## Product Change Notice (PCN)

**Subject:** Addition of back-end production for general-purpose linear IC products (MSOP package products)

**Publication Date:** 6/30/2023

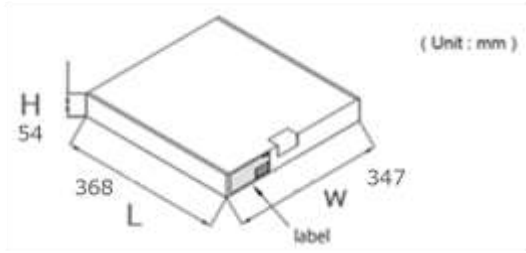
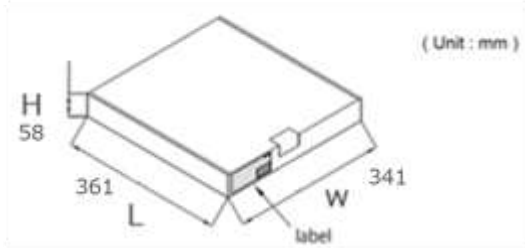
There are some dimensional differences in the outline drawing, but the recommended foot pattern remains the same.

**Product Identification:**

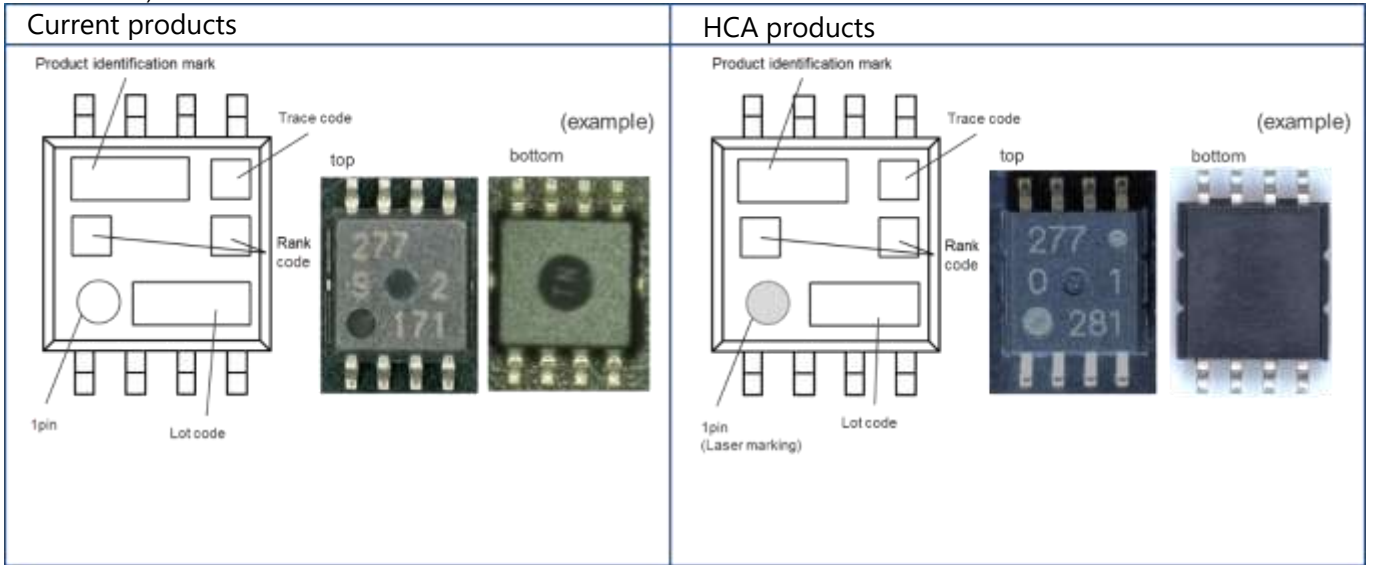
The appearance of the marking/outline (typeface, 1-pin mark, surface finish, etc.) is different, but the marking/outline information is the same. (There is no change in the marking drawing of the delivery specification.)

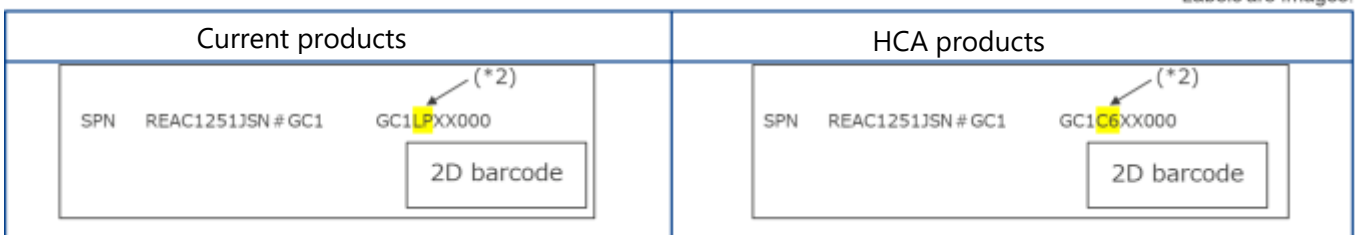
Production sites can be identified by labels (reels, packaging boxes).

Examples of products beginning with UPC  
 (\*1) characters: 04 → RG

Examples of products beginning with REAx  
 (\*2) characters: LP → C6
